Lion circuits DFM

DFM Summary

InstaDFM checks are updated below. Please review.

Top Copper Trace Width

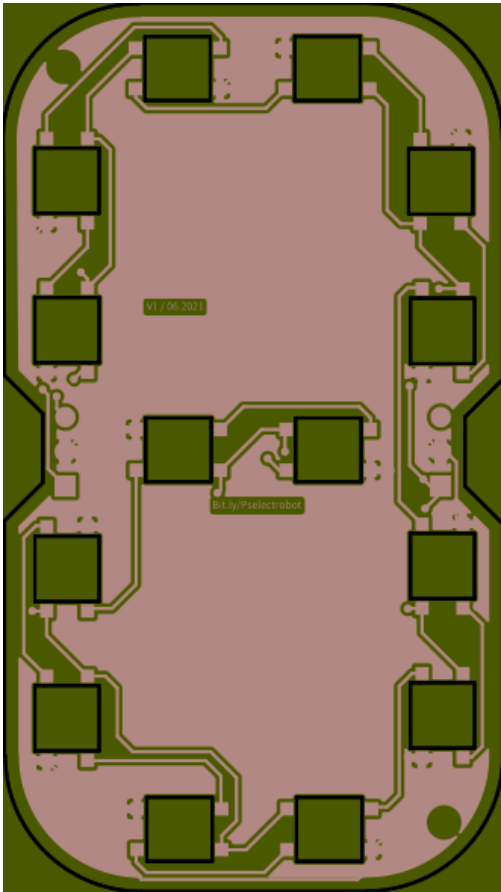
Checks Passed

All trace widths on top copper are > 8 mil

Top Copper Minimum Spacing Between Traces

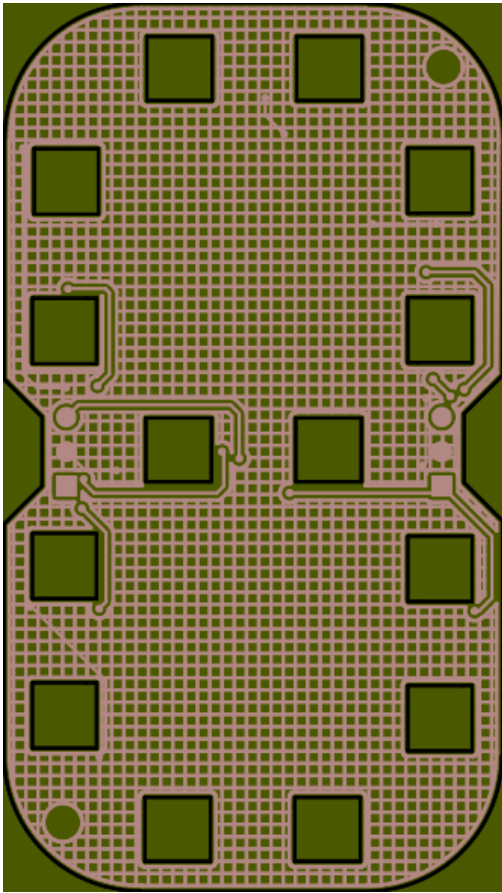
Checks Passed

Spacing between adjacent traces are > 8 mil

Bottom Copper Trace Width

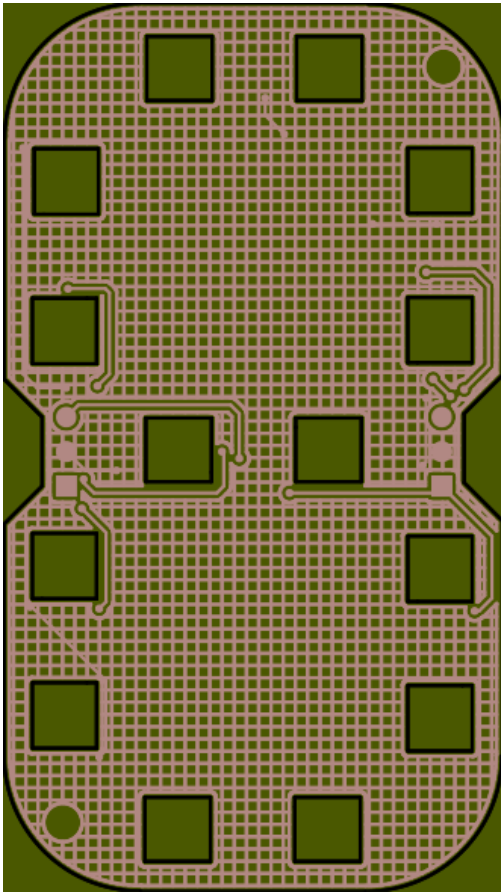
Checks Passed

All trace width on bottom copper are > 8 mil

Bottom Copper Minimum Spacing Between Traces

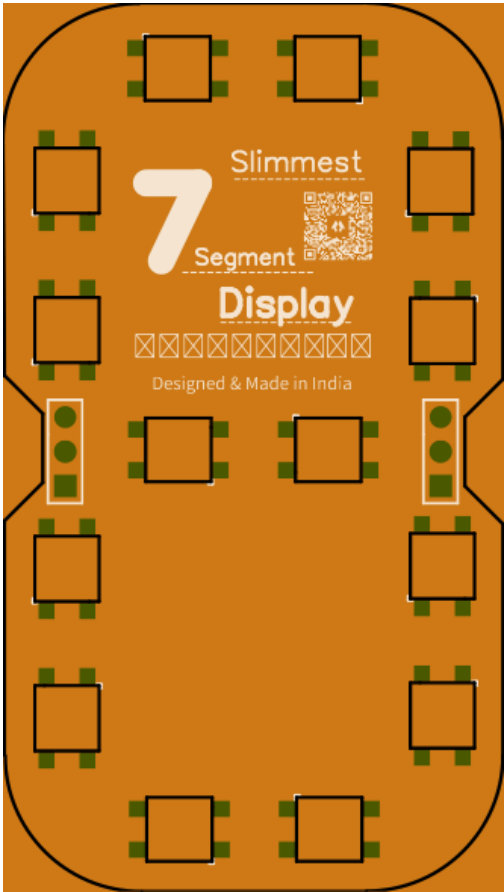
Checks Passed

Spacing between adjacent traces are > 8 mil

Top Silk-Solder Overlap

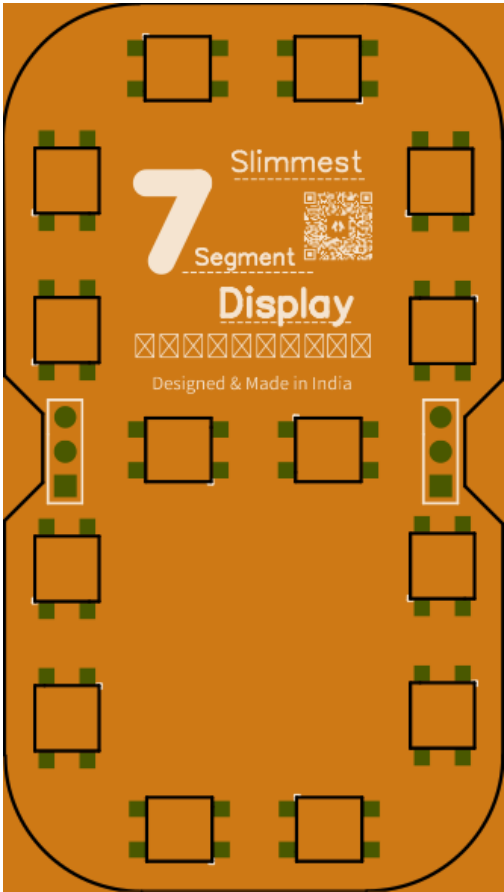
Checks Passed

No overlap between silk screen and solder pad detected.

Top Silk Trace Width

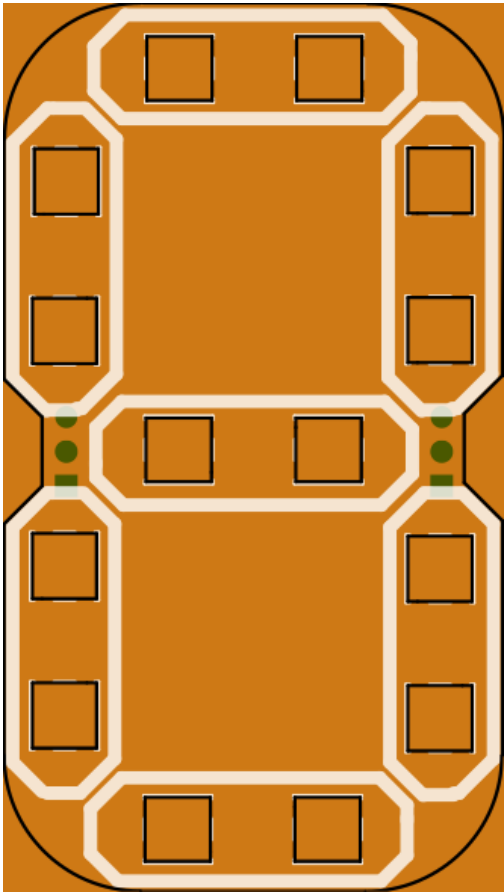
Checks Passed

All silk screen text widths are > 6 mil

Bottom Silk-Solder Overlap

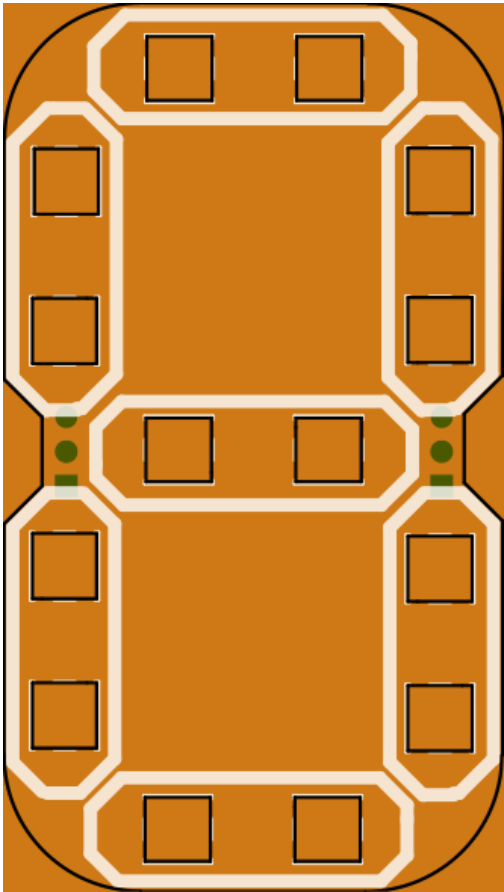
Checks Passed

No overlap between silk screen and solder pad detected.

Bottom Silk Trace Width

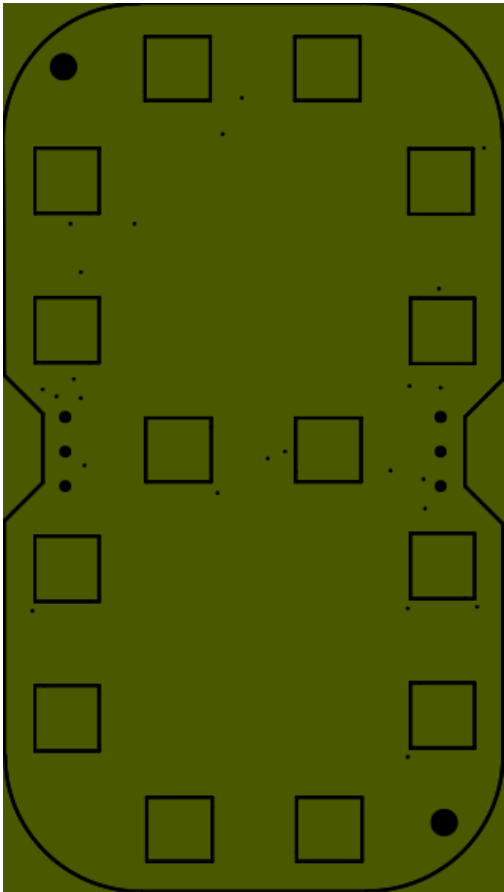
Checks Passed

All silk screen text widths are > 6 mil
